SUBJECT: ISSUANCE OF AMENDMENT (TAC NO. 67019)

The Commission has issued the enclosed Amendment No. 120 to Provisional Operating License No. DPR-16 for the Oyster Creek Nuclear Generating Station, in response to your application dated January 19, 1988.

OYSTER CREEK NUCLEAR GENERATING STATION

Amendment No. 120
License No. DPR-16

Fig. 3.3.1 (a)

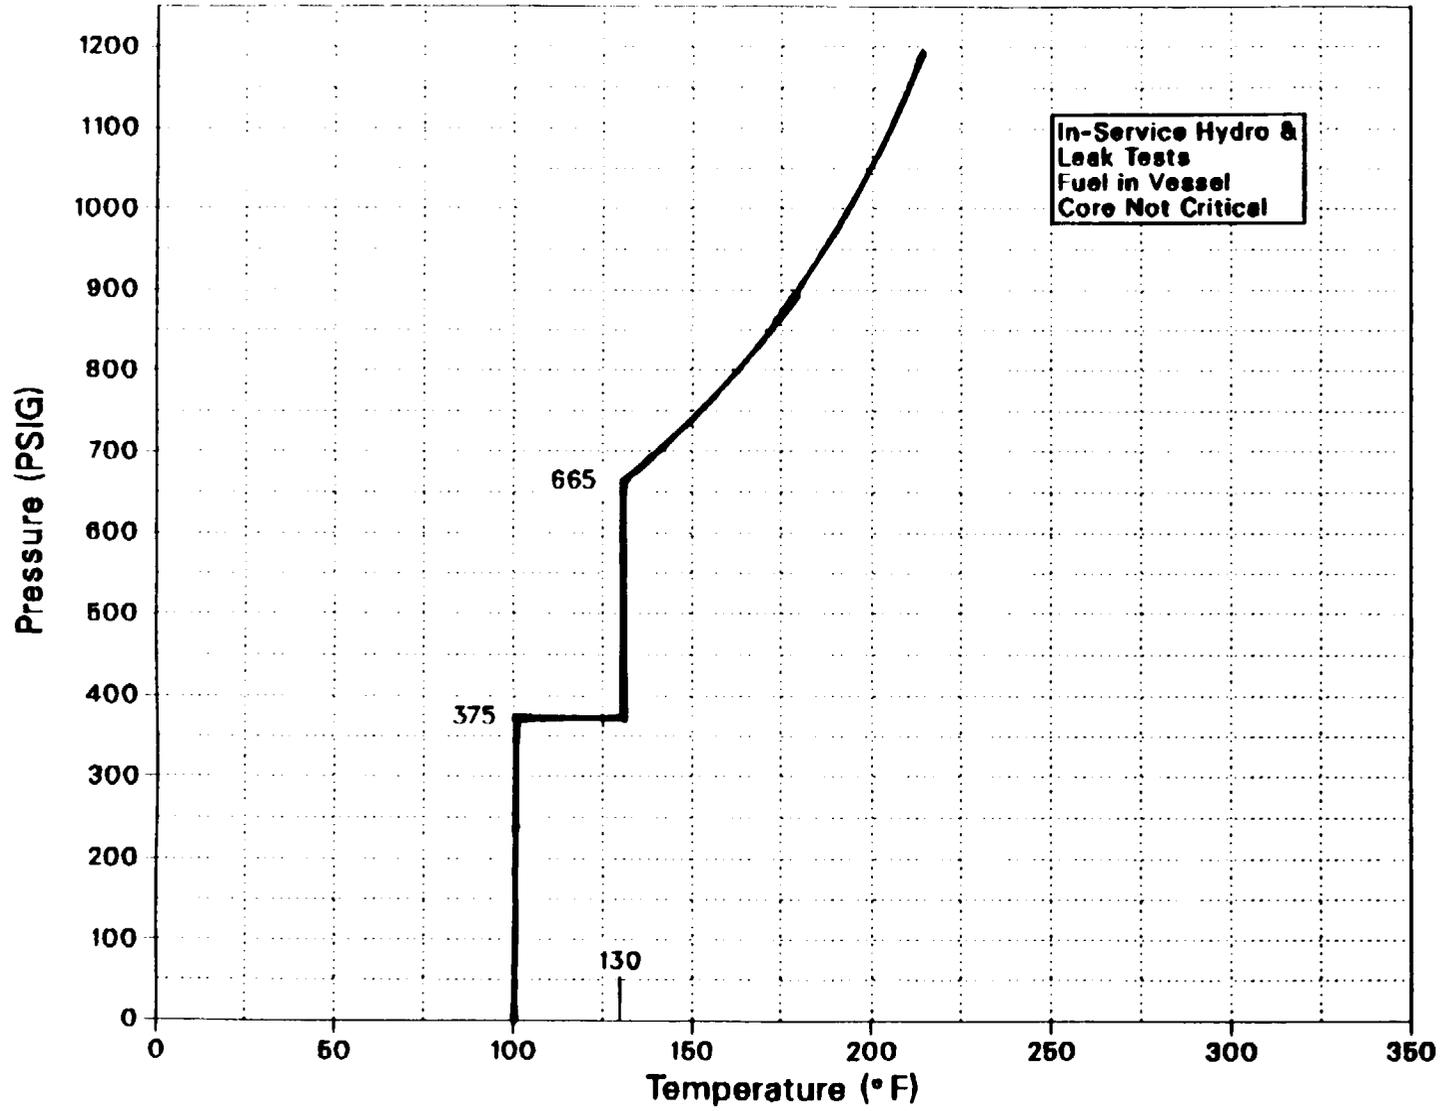
The extent of changes to the Technical Specifications is to incorporate: (1) new pressure-temperature (P-T) operating curves for operation beyond 10 effective full power years (EFPY) and (2) requirements of material surveillance specimens and neutron flux monitors. A definition of Reactor Vessel Pressure Testing and the testing conditions will also be added to the Technical Specifications.

- (i) Reactor Vessel Pressure Tests - the minimum reactor vessel temperature at a given pressure shall be in excess of that indicated by the curve in Figure 3.3.1(a). The maximum temperature for Reactor Vessel Pressure Testing is 250°F.

To construct the pressure-temperature curves, the licensee followed closely the method described in NRC's Standard Review Plan 5.3.2 and ASME Section III Appendix G except in the membrane stress calculation. To calculate the membrane stress, the licensee used the "vessel radius-thickness" relationship whereas SRP 5.3.2 prescribed the "allowable stress-design pressure" relationship. The former gives a lower temperature profile than that of the latter; but, the former method is not necessarily incorrect. The staff determined that the licensee's method was acceptable based on the stress analysis of a cylindrical container having a large radius-to-thickness ratio. (Ref. Roark, R.J., "Formulas for Stress and Strain," 4th edition, page 308). The lower part of the pressure-temperature curves also has to satisfy the specific requirements of 10 CFR 50 Appendix G for boiling water reactors because the boiling water reactor vessel has an inherent pressure-temperature limitation when the reactor water level is within the normal range for power operation and the reactor pressure is less than 10 percent of the preservice system hydrostatic test pressure. The pressure-temperature curve is limited by the closure flange regions that are highly stressed by the bolt preload. The minimum permissible temperature should be 60°F above the initial RT_{NDT} of the flange and when the test pressure is above 20% of the hydrotest pressure, the permissible temperature should be 90°F above the initial RT_{NDT} . Based on an initial RT_{NDT} of 40°F for the Oyster Creek reactor flange, the minimum temperature should be 100°F and the permissible test temperature should be 130°F. Examining the lower part of the pressure-temperature curves, the staff determines that the curves satisfy the 10 CFR 50 Appendix G requirements.

The staff has reviewed the proposed pressure-temperature curves and corresponding paragraphs in the Technical Specifications. The licensee has applied appropriately Regulatory Guide 1.99, draft Rev. 2, 10 CFR 50 Appendix G, and Standard Review Plan 5.3.2 to calculate the adjusted RT_{NDT} and to develop the pressure-temperature curves. The staff concludes that the proposed pressure-temperature curves are valid through 15 EFPY and may be incorporated into the Oyster Creek Nuclear Station Technical Specifications.

Fig. 3.3.1 (b)

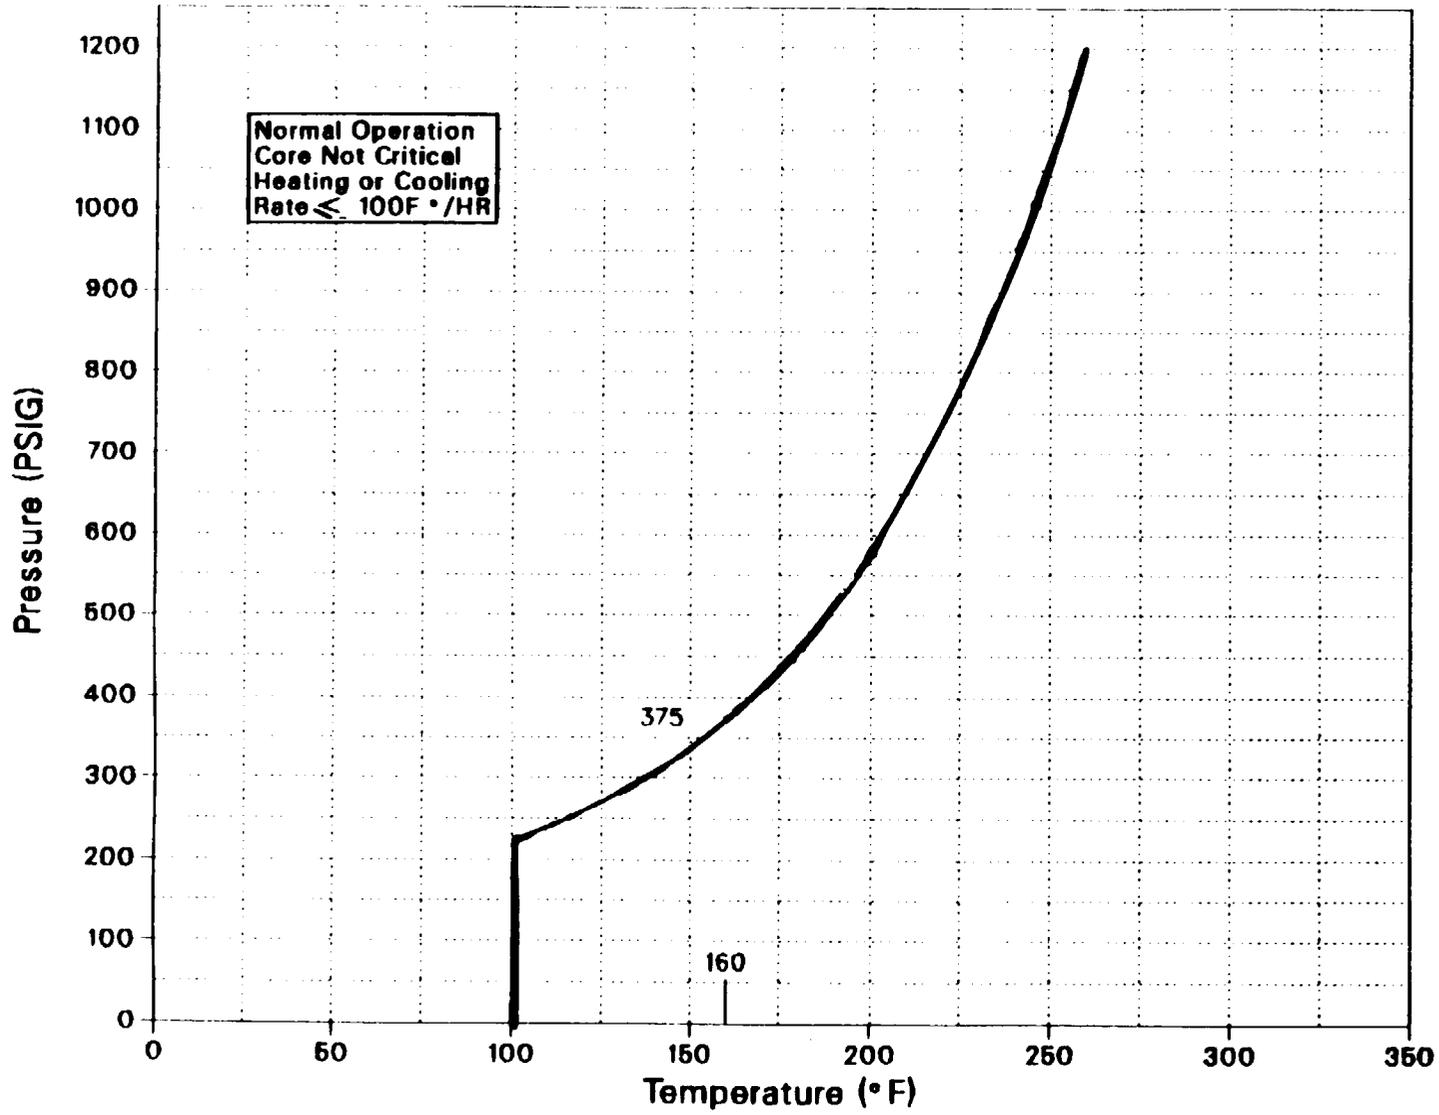
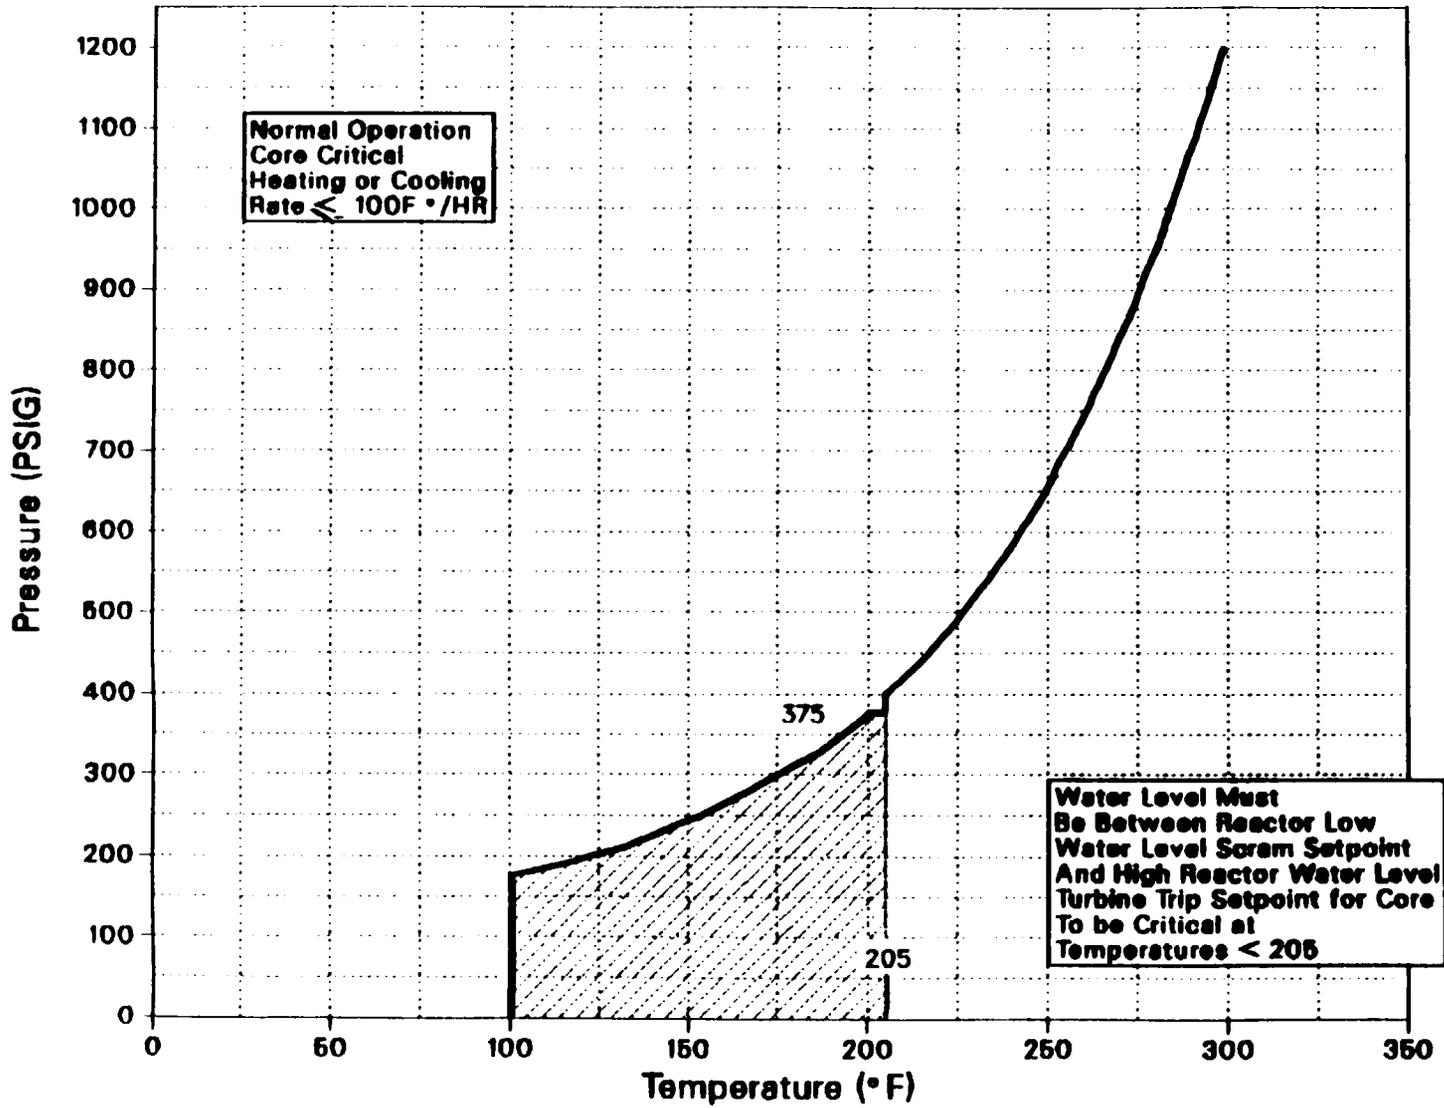
- (ii) Heatup and Cooldown Operations: Reactor noncritical--the minimum reactor vessel temperature for heatup and cooldown operations at a given pressure when the reactor is not critical shall be in excess of that indicated by the curve in Figure 3.3.1(b).

- (iii) Power operations--The minimum reactor vessel temperature for power operations at a given pressure shall be in excess of that indicated by the curve in Figure 3.3.1(c).
Note: Figures 3.3.1(a), (b) and (c) apply when the closure head is on the reactor vessel and studs are fully tensioned.
